MAJOR PROJECT ASSESSMENT
New Berrima Shale Quarry
Project (08_0212)

Director-General's
Environmental Assessment Report
Section 75I of the
Environmental Planning and Assessment Act 1979

July 2012

Figure 7 - Right turn into Taylor Avenue

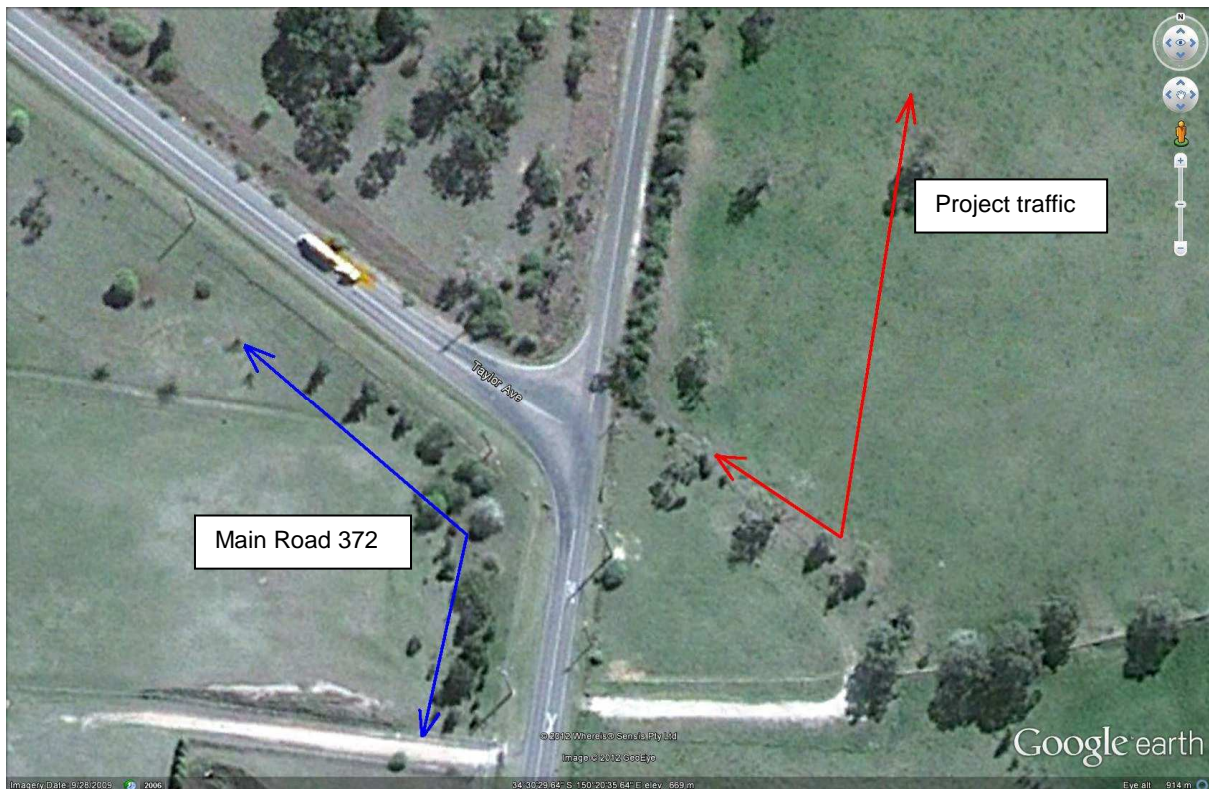
The RMS and Council submissions recommended that Austral upgrade the Berrima Road/Taylor Avenue junction and provide a concrete median on the south bound Berrima Road approach. A basic intersection treatment and concrete median would give priority to Main Road 372 (indicated by blue arrow in **Figure 7**). This would allow Council and RMS to reprioritise the intersection so that southbound vehicles on Berrima Road would be required to give way to vehicles on the main road. Austral suggested that the average one truck every four minutes and 37 seconds does not meet the AUSTROADS threshold for this intersection configuration.

However, the Department considers that the intersection treatment and concrete median is warranted in these particular circumstances because:

- despite retaining a good level of service at the intersection, delays experienced by a south-bound vehicle on Berrima Road could largely be attributed to trucks leaving the project site. A basic intersection upgrade would allow a car to pass an Austral truck waiting to turn right into Taylor Avenue; and
- the right turn manoeuvre into Taylor Avenue is acute (indicated by red arrow in **Figure 7** below), which increases the chances that a driver might opportunistically cut the corner, giving rise to a risk of traffic conflict with traffic on main road 372. Reprioritising the intersection and provided a concrete median would ensure a proper and lawful right turn into Taylor Avenue and the safe function of Main Road 372.

Figure 8 - Location of nearby residences

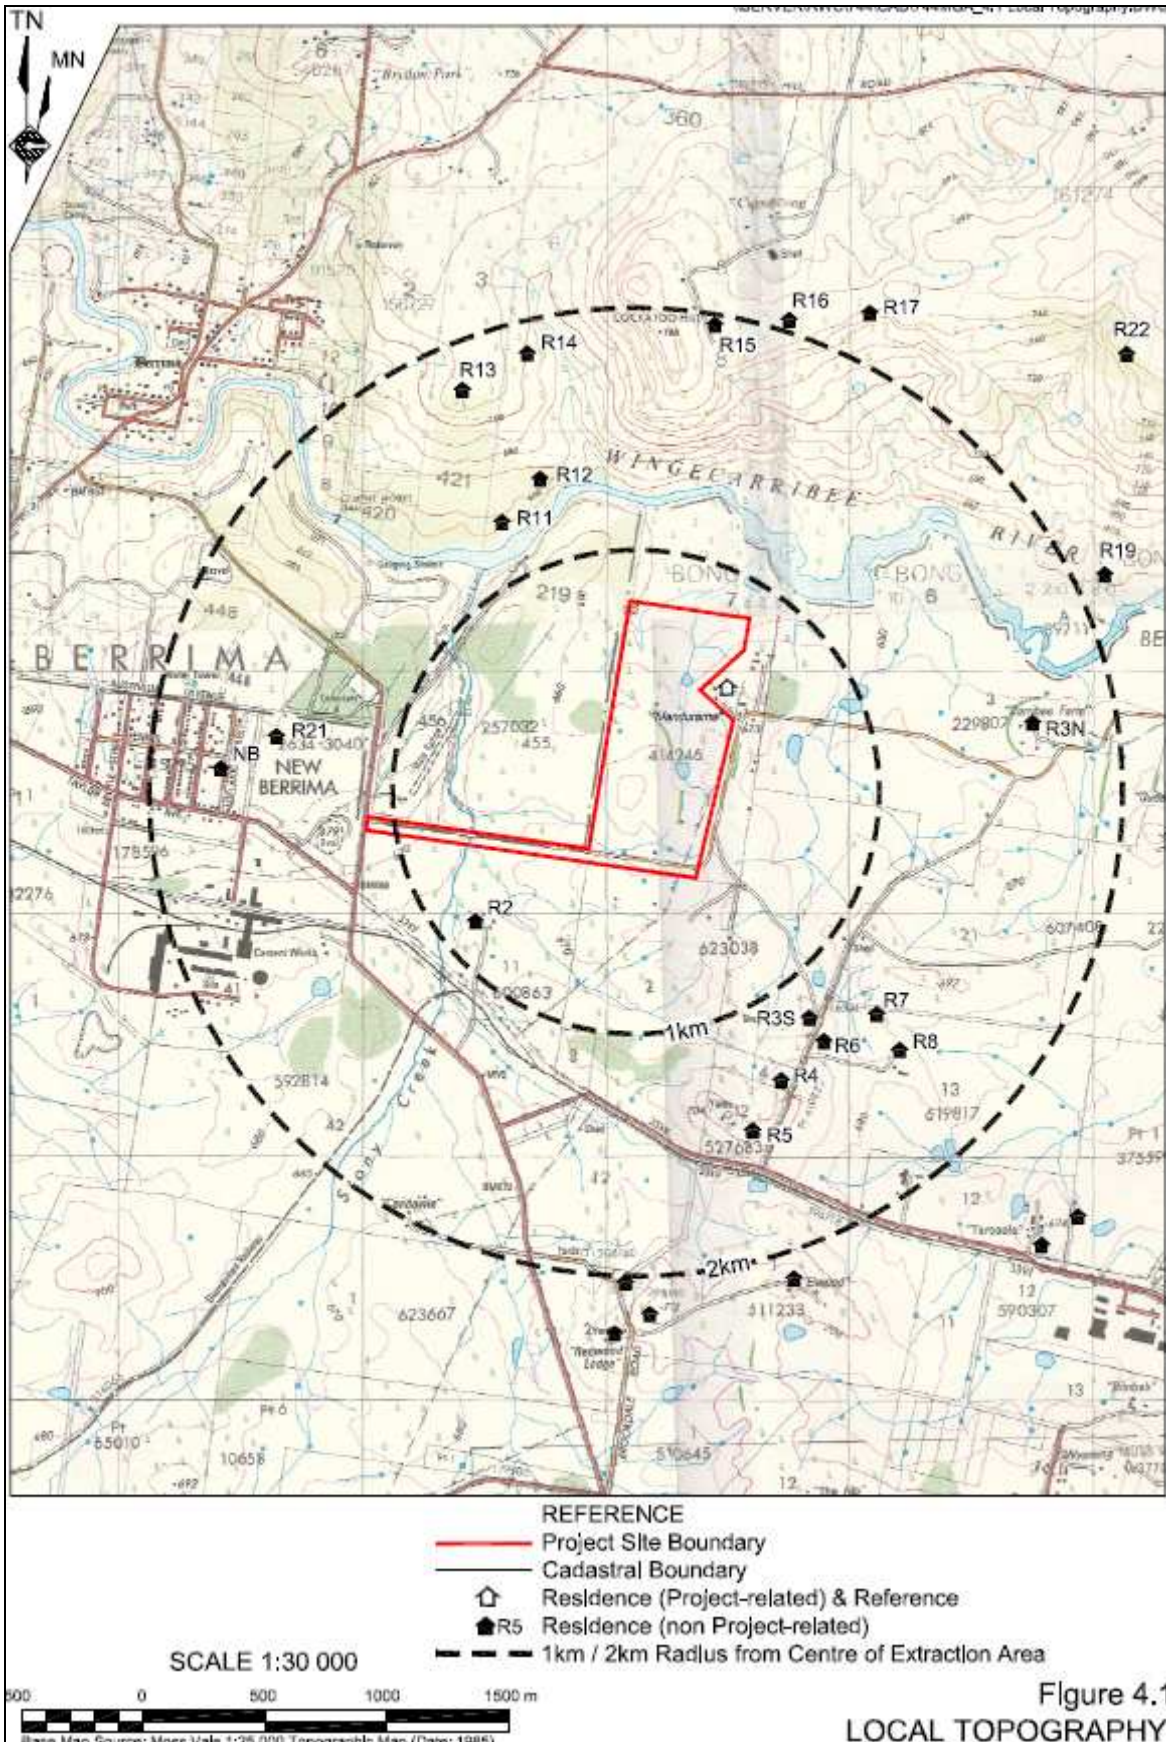
Two public submissions raised the issue that the cumulative assessment of PM₁₀ should have:

- taken into consideration point source emissions from the Blue Circle Cement Works in New Berrima to the west of the site; and
- been modelled from the most northerly/north-west location on site, instead of in the southern section of the site.

In respect of the first point, the assessment-model does model emissions data relating to the cement works. The data was sourced from reports to the National Pollution Inventory. The data was modelled crudely as a single volume source, because point sources are not reported. To over-compensate for the crude methodology, the model assumed continuous emissions at the cement works, which would have yielded exaggerated emissions results. Therefore, the Department is satisfied that the predicted cumulative impacts for the Project and the cement-works are conservative and need not be modelled in finer detail.

Regarding the second point above, there is no extraction, overburden dumping or stockpiling in the northern part of the site. The extraction area in the southern part of the site, as used in the assessment-model, is the most appropriate location to model air quality impacts from.
